## NVM Express Technical Errata

<b>Errata ID</b>	015
<b>Change Date</b>	6/15/2011
<b>Affected Spec Ver.</b>	NVM Express 1.0a
<b>Corrected Spec Ver.</b>

This erratum makes clarifications and corrections to the end-to-end data protection material.

This erratum makes clarifications to the Firmware Image Download and Get Log Page commands.

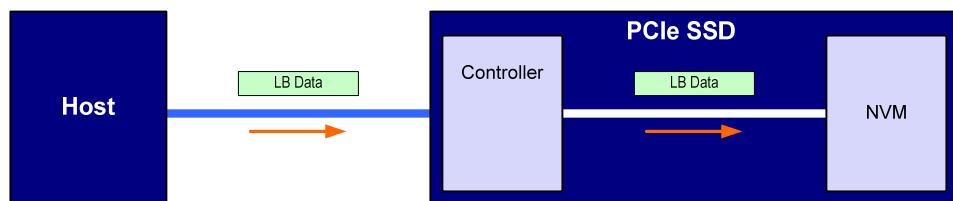
***Update the paragraph preceding Figure 143 in section 8.3 as shown below:***

Figure 143 illustrates the protection information processing that may occur as a side effect of Read command processing. The processing parallels Write command processing with the exception that LBA logical block data flows in the opposite direction. When the PRACT bit is cleared to '0' and the namespace was formatted with protection information, LBA logical block data and metadata are transferred from NVM to the host and checked by the controller. When the PRACT bit is set to '1' and the namespace was formatted with protection information, LBA logical block data and metadata are transferred from the NVM to the controller. The controller checks the protection information and then removes it from the metadata before passing the LBA to the host. If the namespace format contains metadata beyond the protection information, then the protection information is not stripped regardless of the state of the PRACT bit (i.e., the metadata field remains the same size in the host as that in NVM).

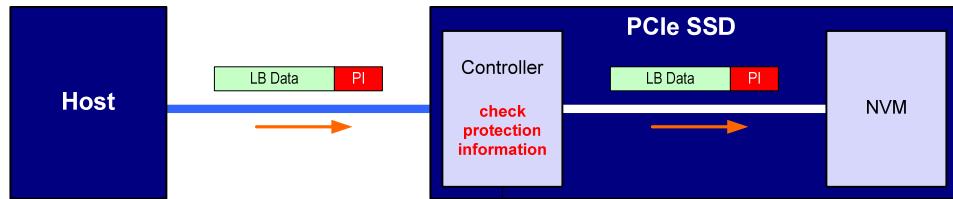
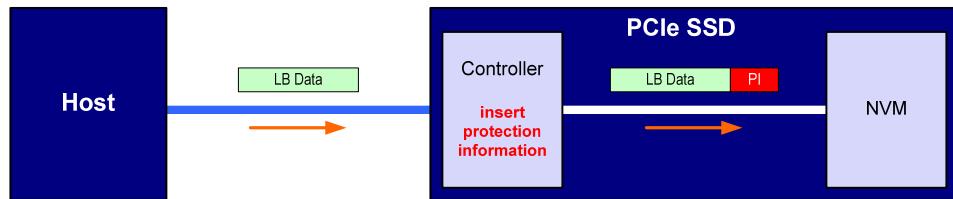
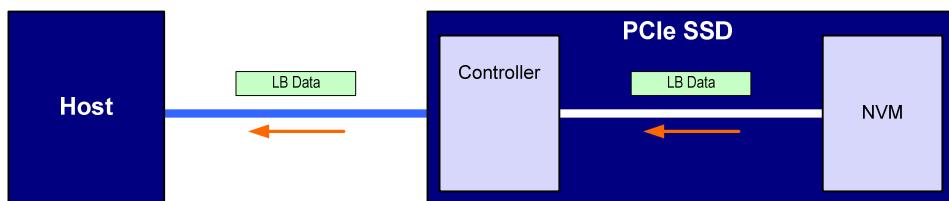
Replace Figure 142 with updated figure below. LBA Data changed to LB Data and description for item b) and c) updated.

(a) No Protection Information

(b) Protection Information with PRACT bit cleared to '0' (i.e., pass)

(c) Protection Information with PRACT bit set to '1' (i.e., insert)

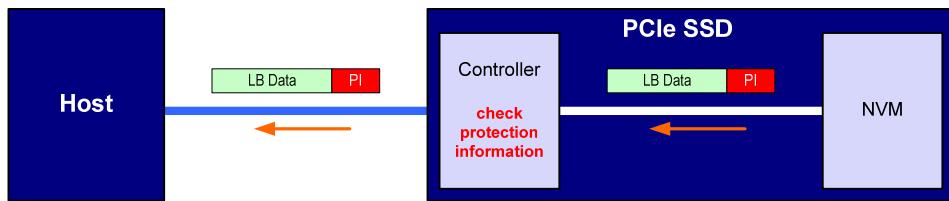
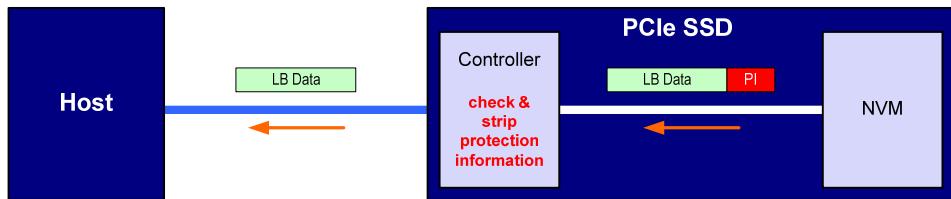
Replace Figure 143 with updated figure below. LBA Data changed to LB Data and description for item b) and c) updated.

(a) No Protection Information

(b) Protection Information with PRACT bit cleared to '0' (i.e., pass)

(c) Protection Information with PRACT bit set to '1' (i.e., strip)
